ITEM 5: 202003040010 – Farmstead Subarea H (Development Plan)

Development Plan for Subarea H of the Farmstead Development and contains 87 single-family lots on approximately 21.52 acres, with a development text.

Staff Recommendation

Proposed Site Plan

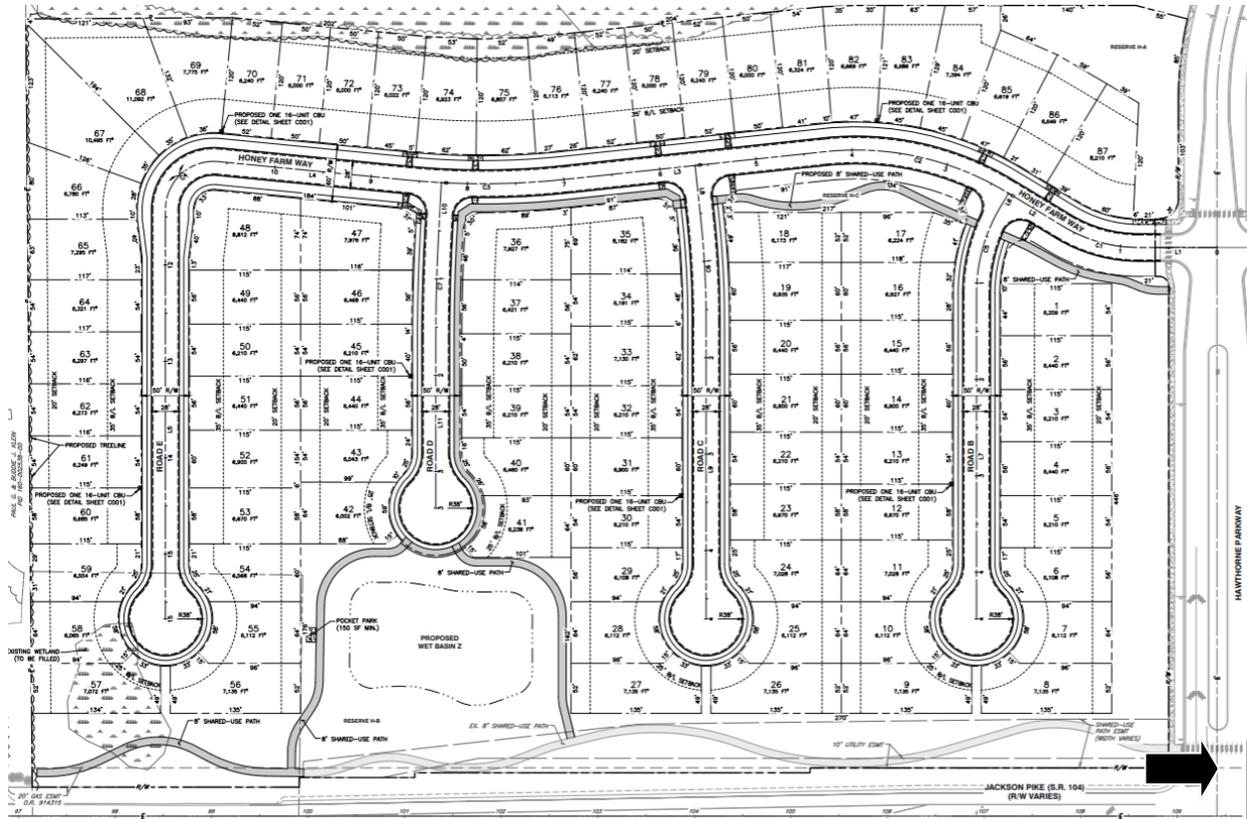
The site plan is incorporating four cul-de-sac roadways, which was an intentional site layout choice, to allow for side yards of only six homes to be oriented toward Jackson Pike. This is compared to other site layouts that would have resulted in 12 or more backs of homes facing Jackson Pike. In addition to the more limited lots adjacent to Jackson Pike, the applicant will continue the same mounding, tree screening and other landscaping between the homes and Jackson Pike as was approved for the development north of Hawthorne Parkway. Landscaping and mounding is also proposed along Hawthorne Parkway. Between the third cul-de-sac and Jackson Pike there will be a wet basin, designed to meet the criteria within the Stormwater Design Manual to ensure quality design for residents of the development as well as where visible from Jackson Pike.

The wet basin pond is proposed to be landscaped with different deciduous and evergreen trees and shrubs. Only 13 trees are required, but 18 have been proposed. Additional landscaping is required around the pond where visible from Jackson Pike. This will include shrubs, perennials, stone outcroppings and shoreline protection with stone slabs and a wetland shelf. The applicant has provided landscaping and hardscaping around the pond that combines the Tier I and Tier II requirements, due to the partial visibility from Jackson Pike. It appears as if the reinforced fencing along the southern portion of the site fronting Jackson Pike is located where the wet basin had been in previous submissions. Staff recommends that the reinforced fencing be relocated to a more appropriate location in reference to the wet basin.

1. Further detail shall be submitted to the Development Department for the homes located at the terminus of the proposed cul-de-sacs, showing additional architectural detail and appropriate landscaping to ensure a quality streetscape. These lots are identified on the plan sheets as 8, 9, 26, 27, 41, 42, 56, 57.
2. The location of the protective fence along Jackson Pike shall be amended on plans to be where adjacent to the retention pond.
3. Please correct the typographic error for the note on the reinforced fencing to state that the detail is referenced on sheet 701, instead of 702.
